What's wrong

sfp

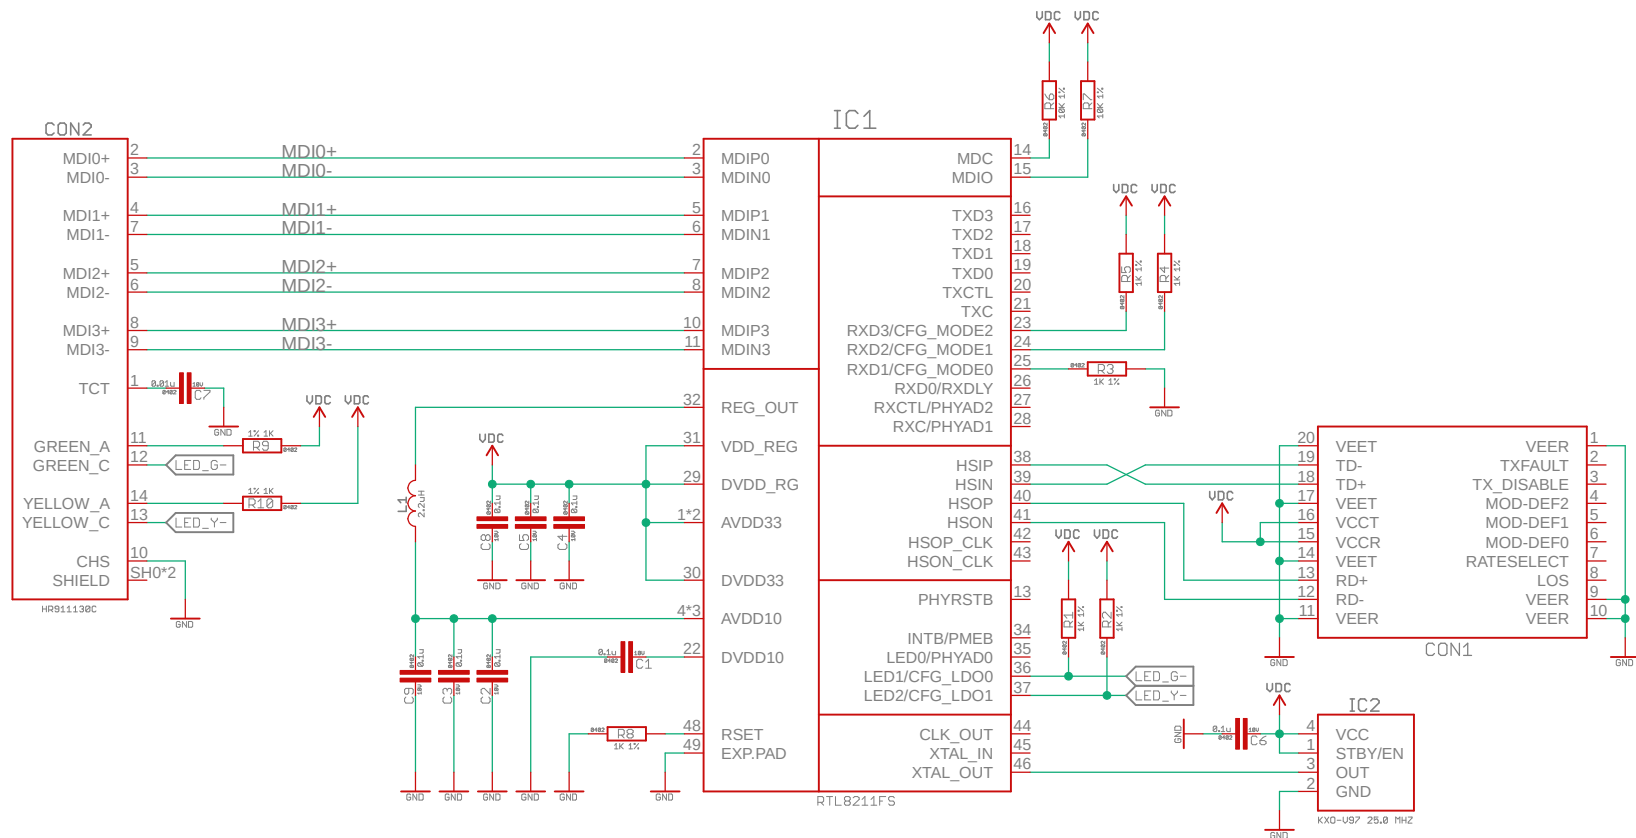
https://en.trxcom.net/Products_details/386.html
Here is says there are NO MAGNETICS inside TRJE101AGNL

- 1) Poorly draun Schematic.
- 2) TXD+/TXD- on SFP connector side must be swapped
- 3) Ethernet connector has no embedded magnetics. Need another connector
